**ZILKER NEIGHBORHOOD ASSOCIATION COMMENTS (12 SEP 2019)
TO THE CITY COUNCIL ON 211 SOUTH LAMAR PUD REZONING**

EXHIBIT 1

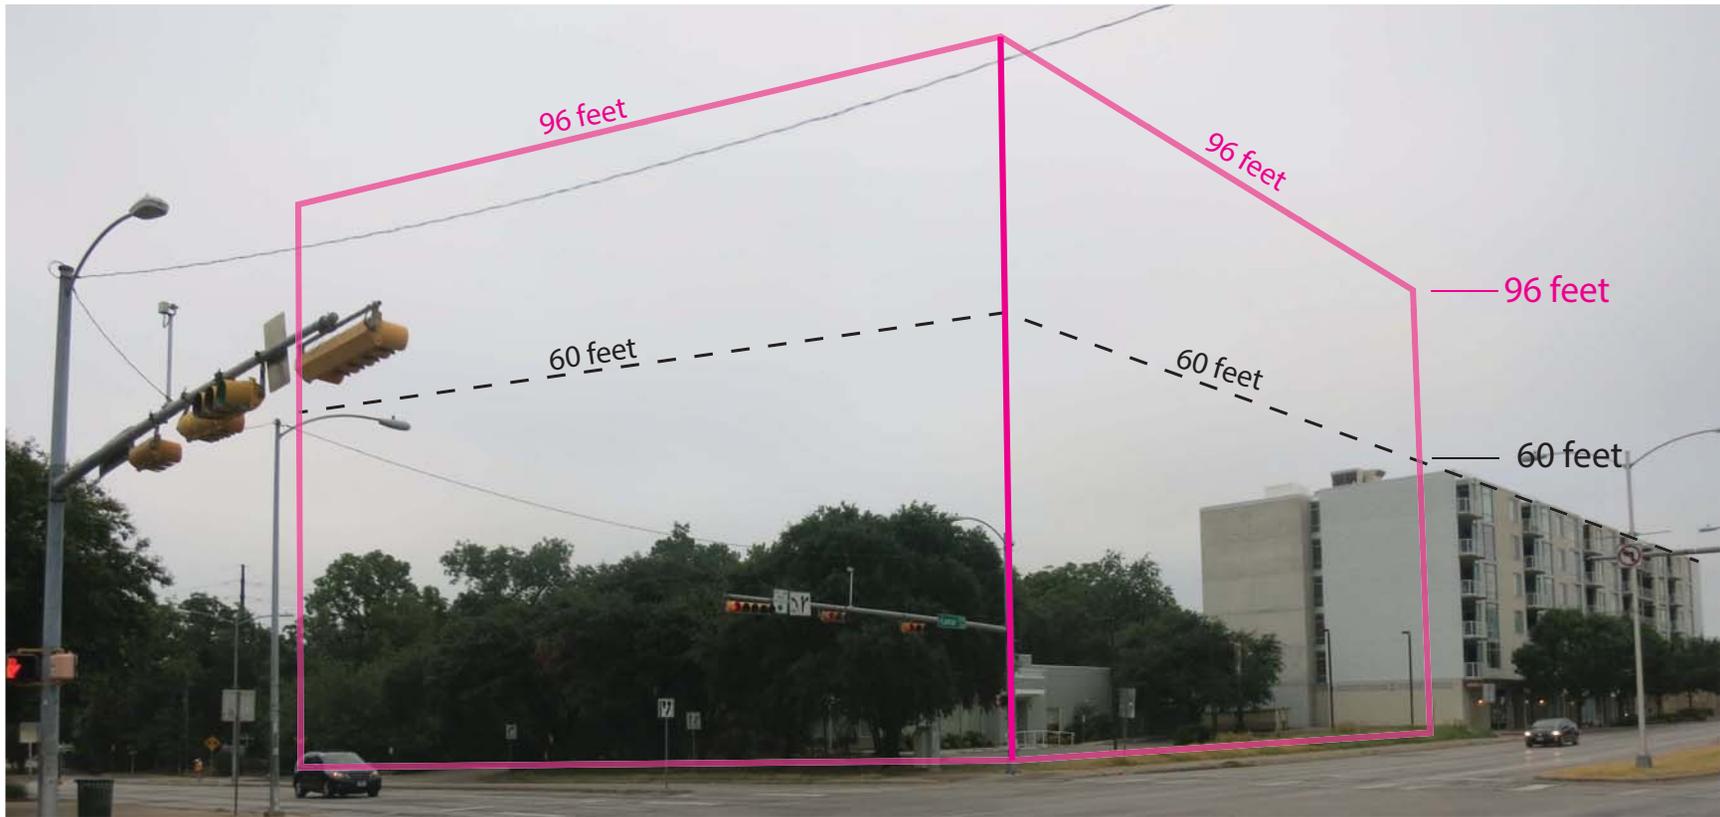
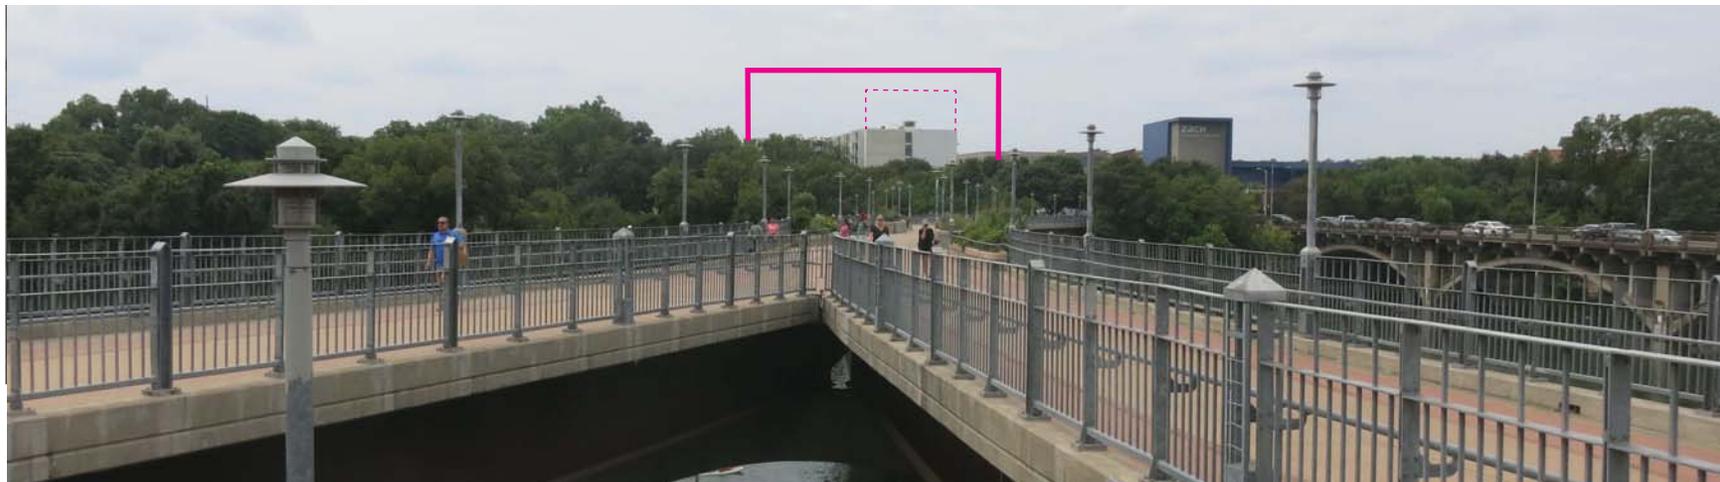
In theory, the original project had a maximum height of 96 feet for building block one and 78 feet for building block two; the new project is even higher with building block one remaining at 96 feet but building block two increasing by eight feet to 86 feet. Thus, this proposed project is inferior to the original project because it is even taller. This building will dominate the view along Butler Shores and the southern view from the Pfluger Pedestrian Bridge as one crosses Lady Bird Lake (see Exhibit 1). It will loom over the Butler Pitch and Putt Golf Course where the view still feels like a park setting, but it will not feel like a park setting when a 96-foot glass building looms over the northern end of the course (see current view from Butler Pitch and Putt in Exhibit 2).
